November 22, 2023

Subject: Rock Cove Hospitality Mitigation Addendum

This letter has been prepared to address changes to the Rock Cove Hospitality site plan and to address comments from Washington Department of Fish and Wildlife (WDFW) and the Department of Ecology (Ecology). This letter is a supplement to the *Critical Areas and FWHCA Report for Rock Creek Cove Hospitality* updated on May 3, 2023 (ELS 2023). Based on results and comments from a hearing with the City of Stevenson on October 9, 2023, the Rock Cove Hospitality site plan was revised to reduce the proposed impacts to the Fish and Wildlife Habitat Conservation Area (FWHCA) buffer for the Columbia River (Rock Cove) which is a Shoreline of Statewide Significance (Type S).

Figure 1
 EXISTING CONDITIONS
 Rock Cove Addendum
 FDM Development
 City of Stevenson, Skamania County, Washington
 Section 1, Township 2N, Range 7E, W.M.

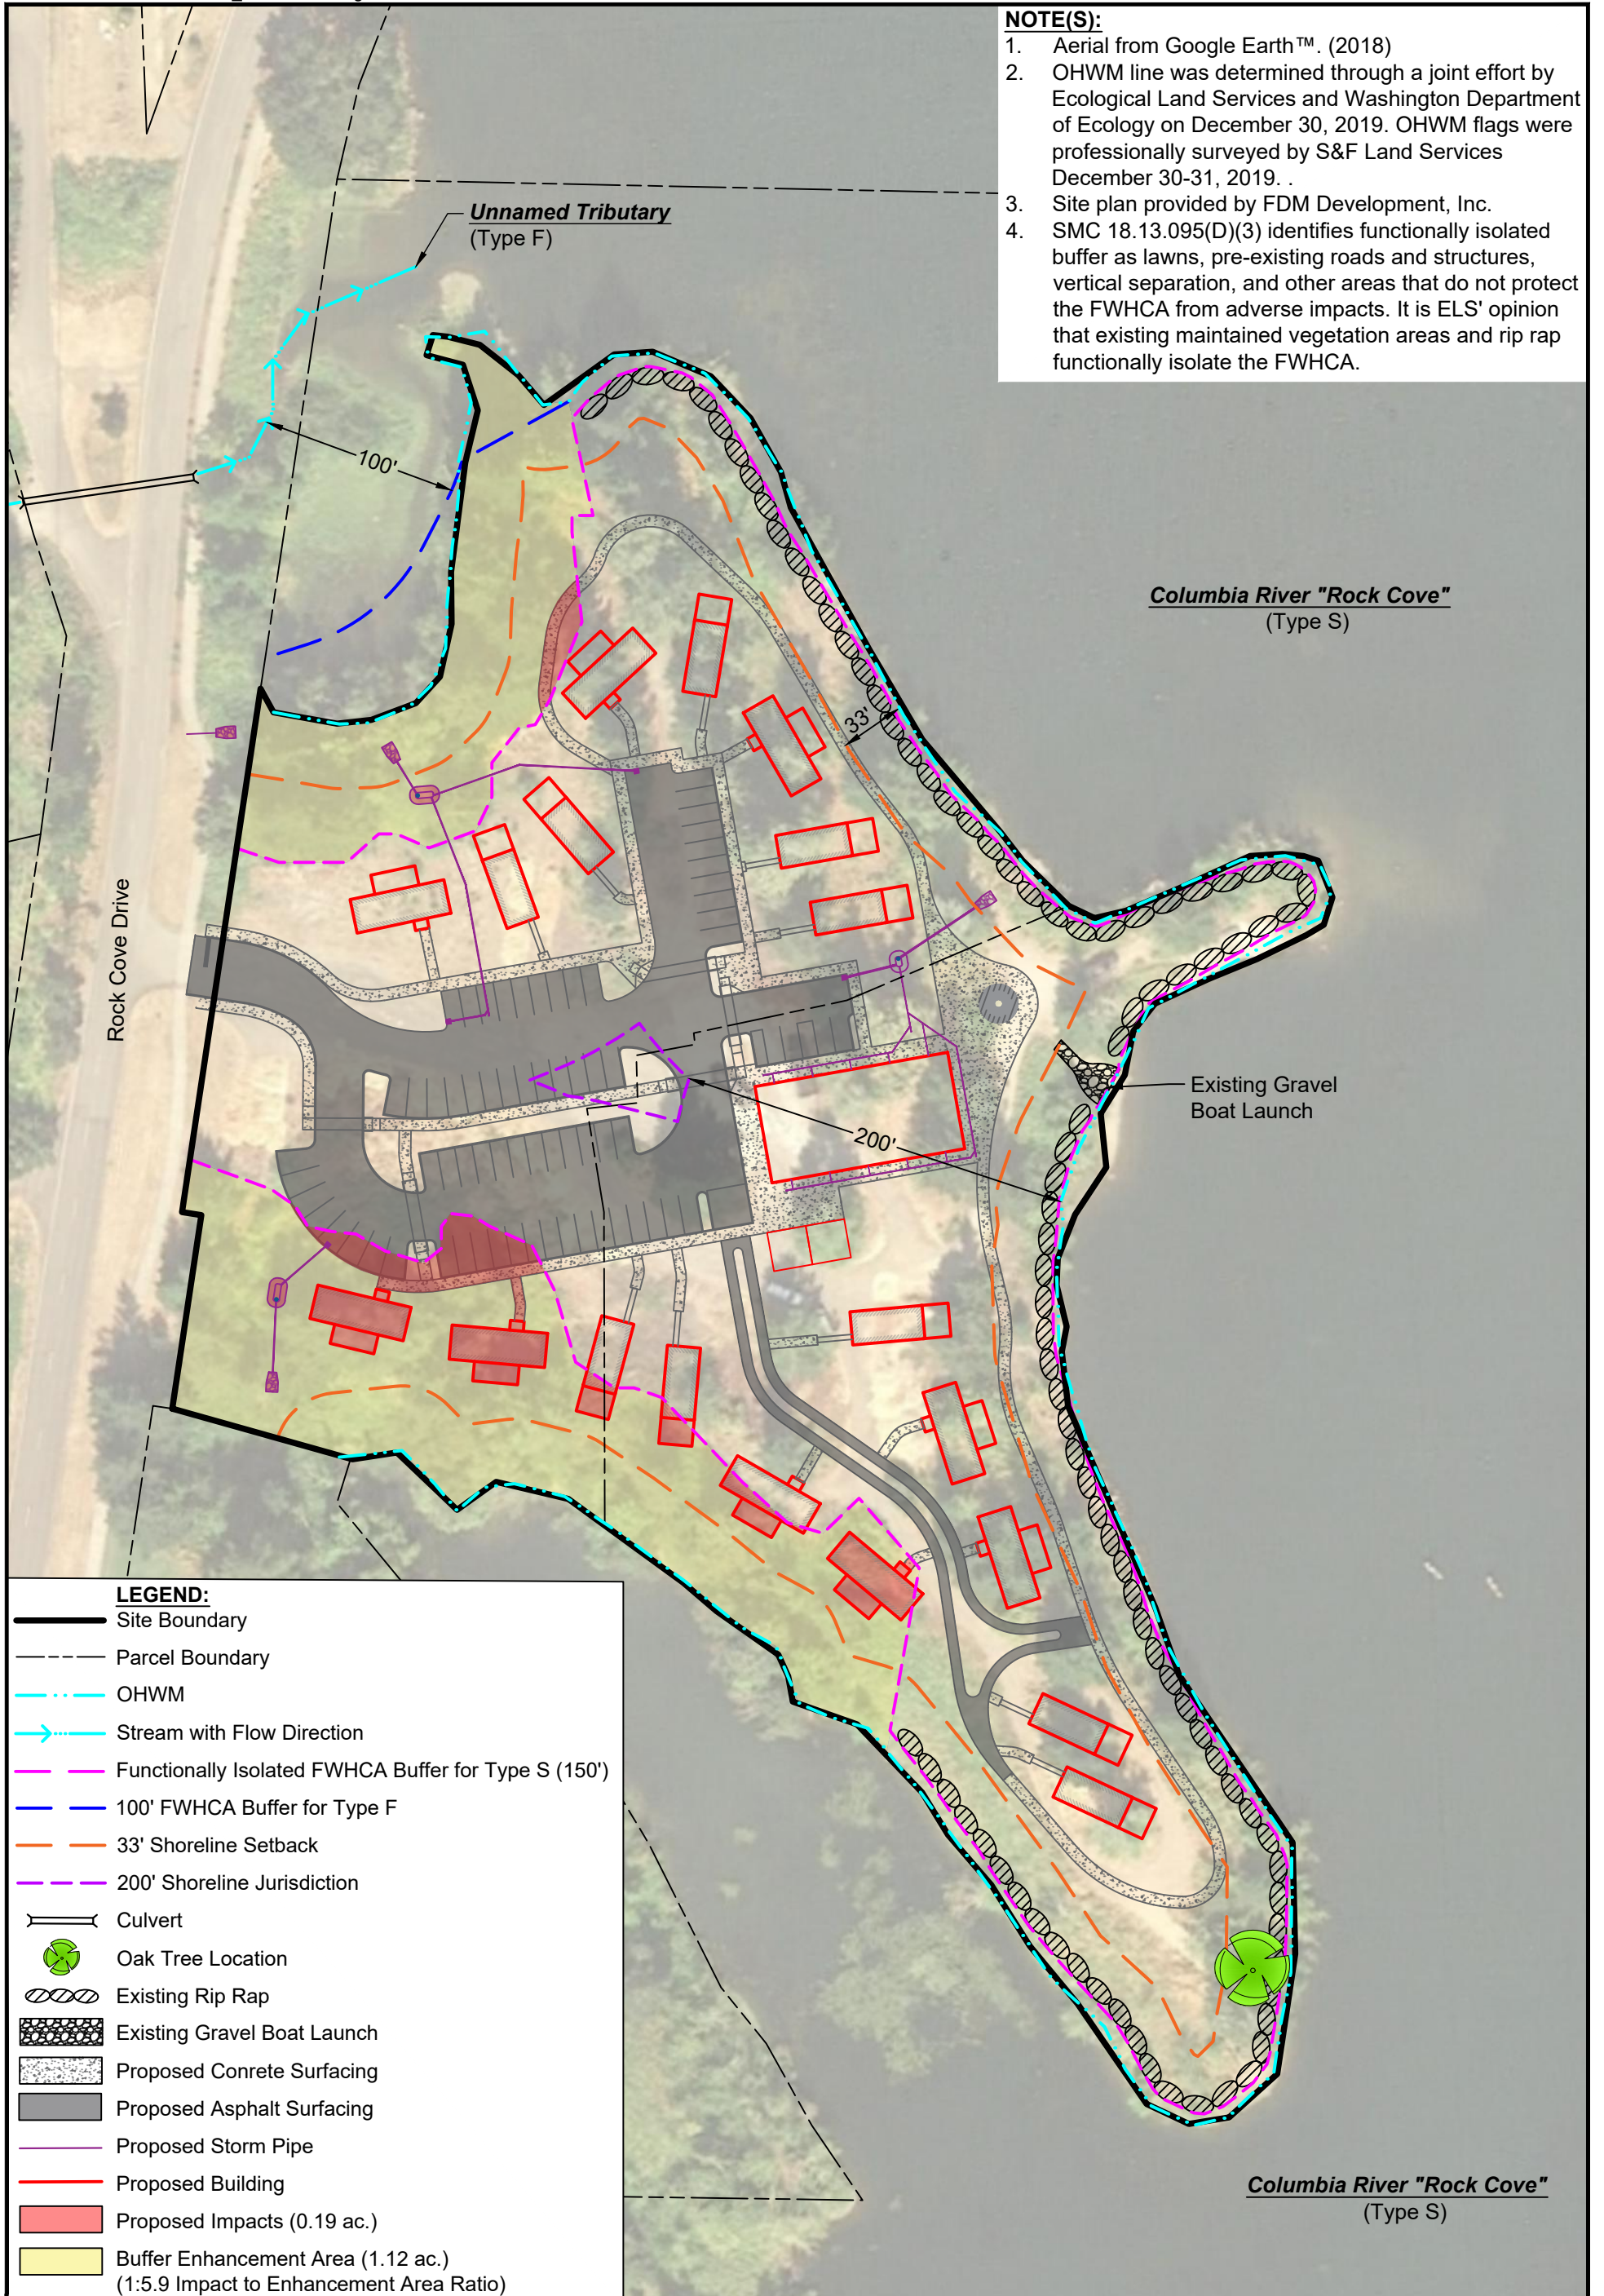
- *Ecology does not think the maintained vegetation areas shown in Figure 1 should qualify as functional isolation.*

According to the SCO 18.13.095(D)(3), lawns and other mowed areas can be considered as functional separation from FWHCA buffers. These areas have been mowed and maintained since the year 2000 as can be seen on Google Earth aerial imagery. Additionally, these areas were photographed in January of 2020 in preparation of the original draft of the critical areas report by ELS (Photoplate 3 and 4). It is ELS' opinion that the provided evidence meets the requirement in the SCO and that these areas do indeed meet the definition of functional isolation.

Figure 2
 PROPOSED CONDITIONS - APRIL 2023
 Rock Cove Addendum
 FDM Development
 City of Stevenson, Skamania County, Washington
 Section 1, Township 2N, Range 7E, W.M.

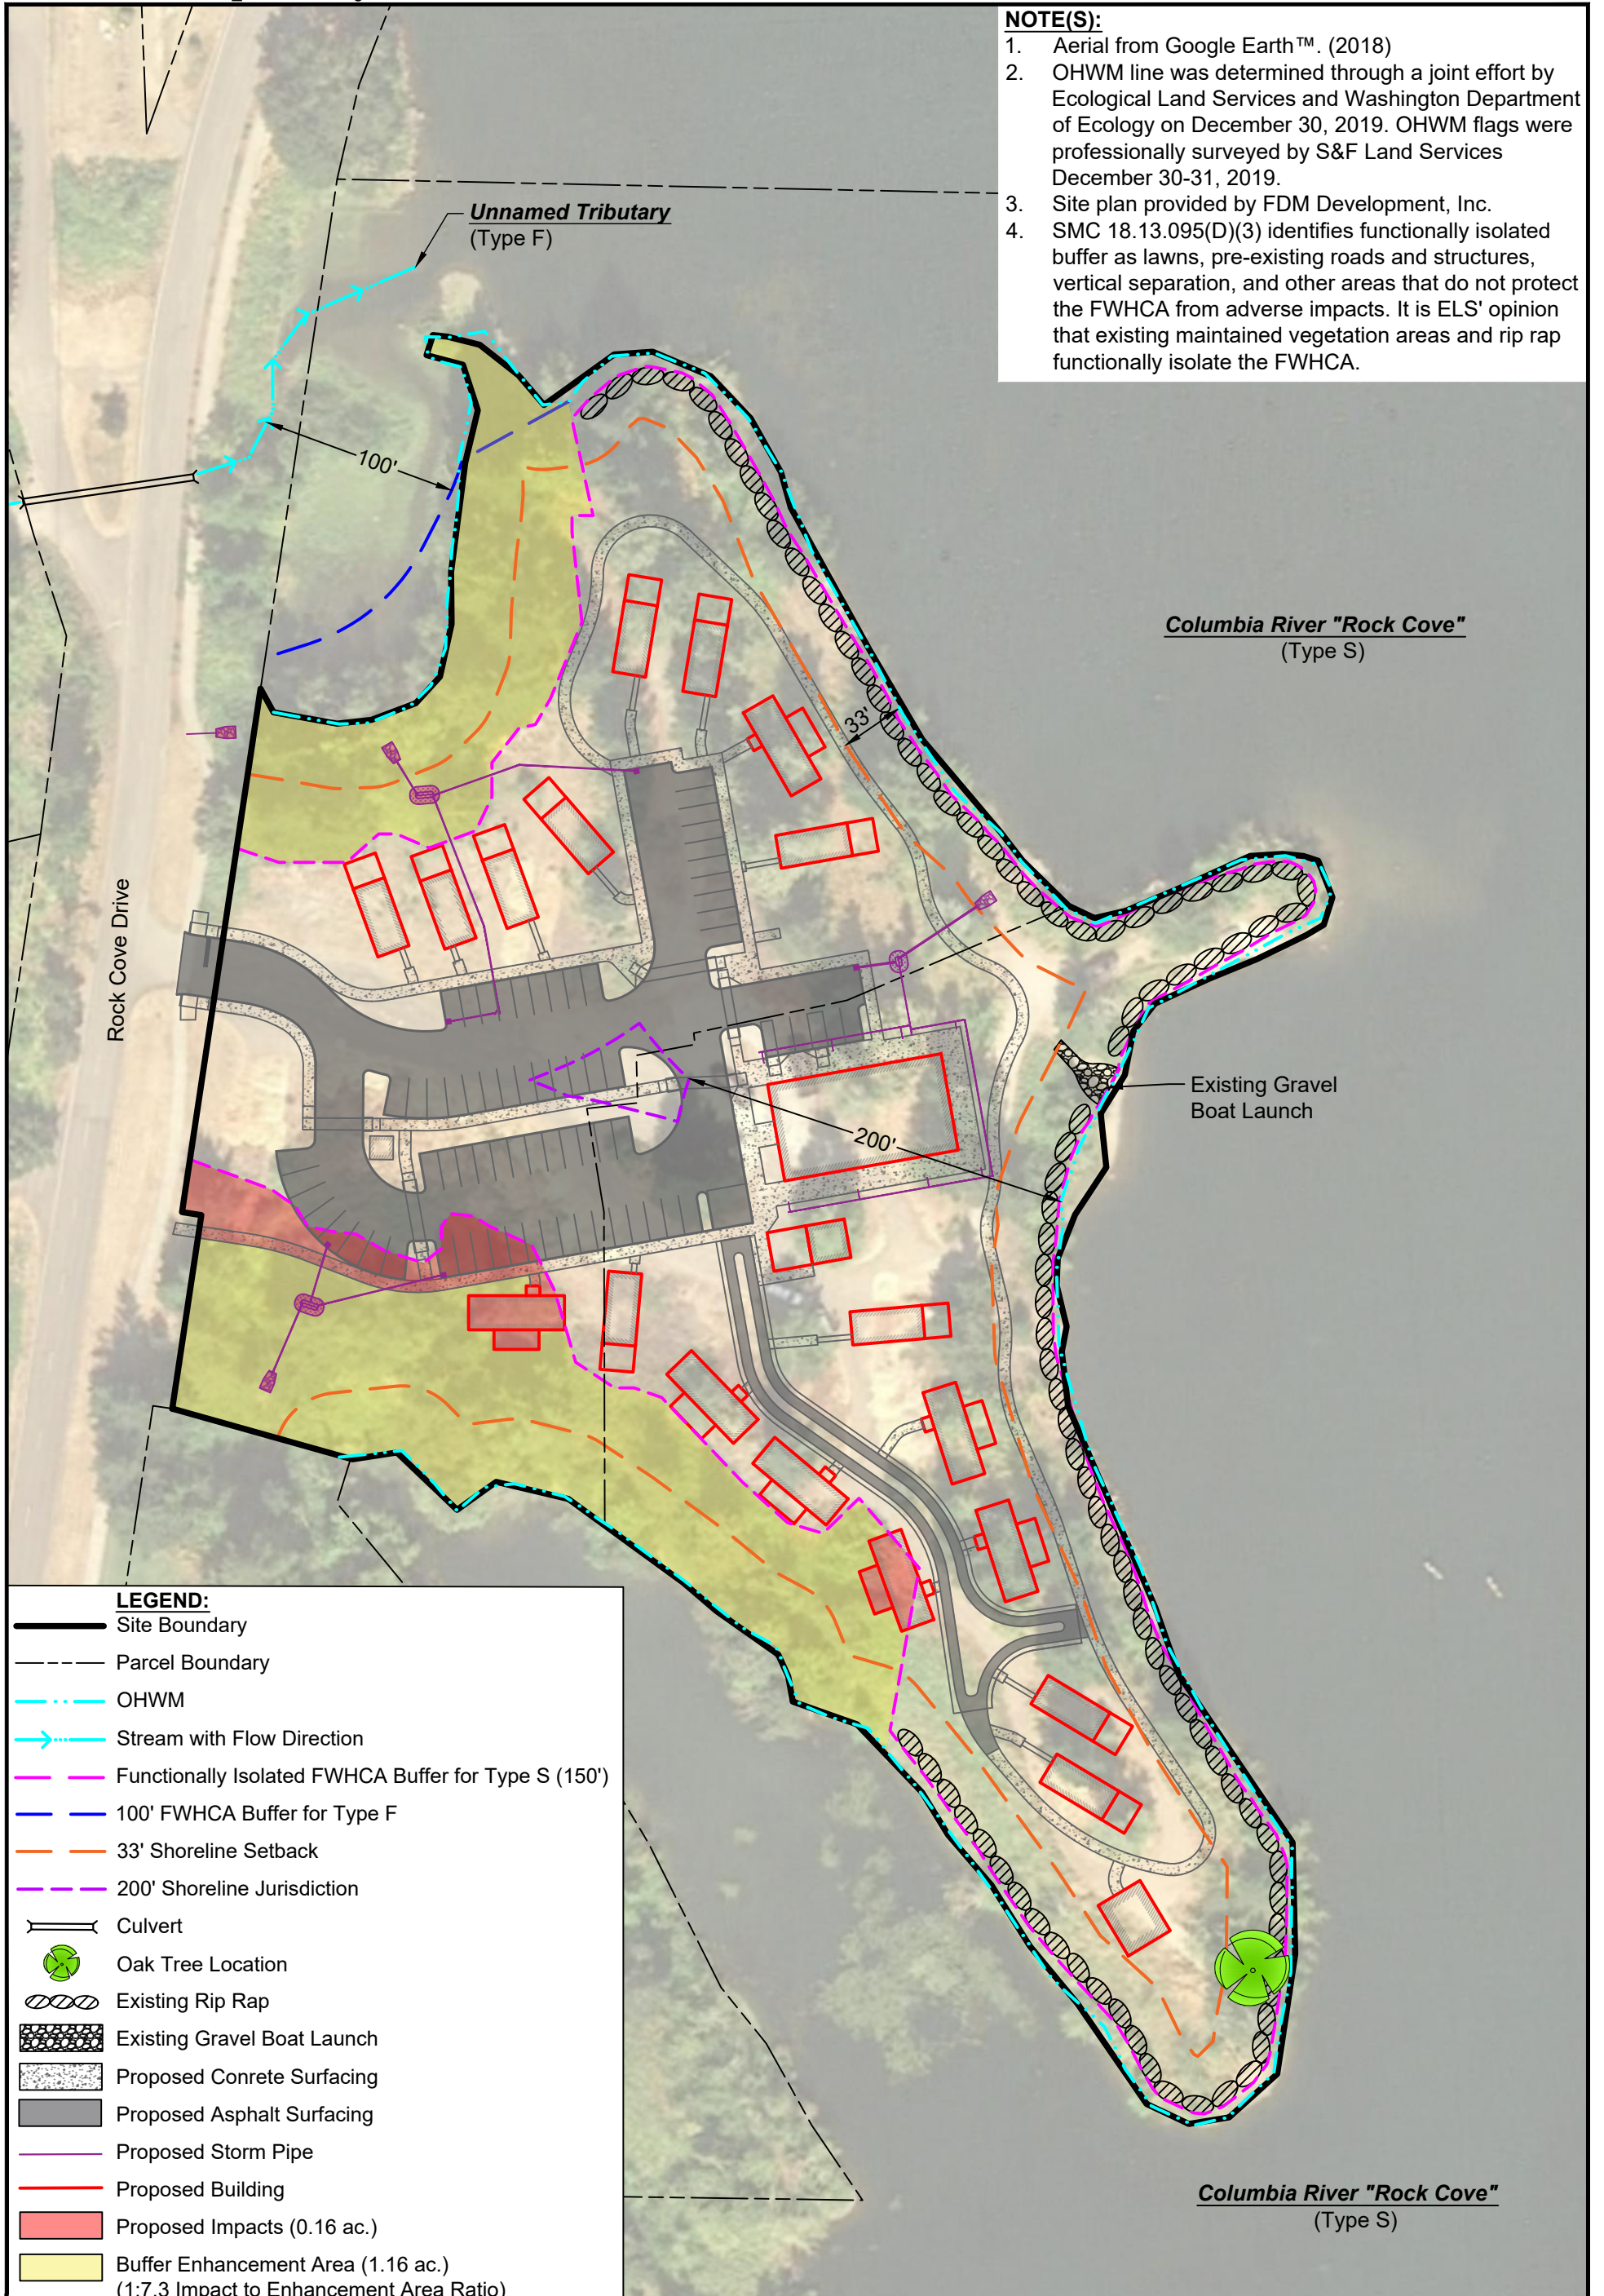
- *Ecology states that vegetation removal within shoreline jurisdiction requires mitigation at the mitigation ratios listed in the SMP Table 6.2*

A nominal quantity of shrubs will be removed from the impact areas shown on Figure 3. These shrubs consist of native groundcover and understory, non-native vegetation, and invasive species such as Himalayan blackberry. According to Table 6.2 of the SMP, the required mitigation ratio is 1:1 for these vegetation types. This proposed project exceeds the required 1:1 mitigation ratio required for enhancement by the SCO with a ratio of approximately 1:7.3, therefore, vegetation proposed for removal within shoreline jurisdiction will be fully compensated for.
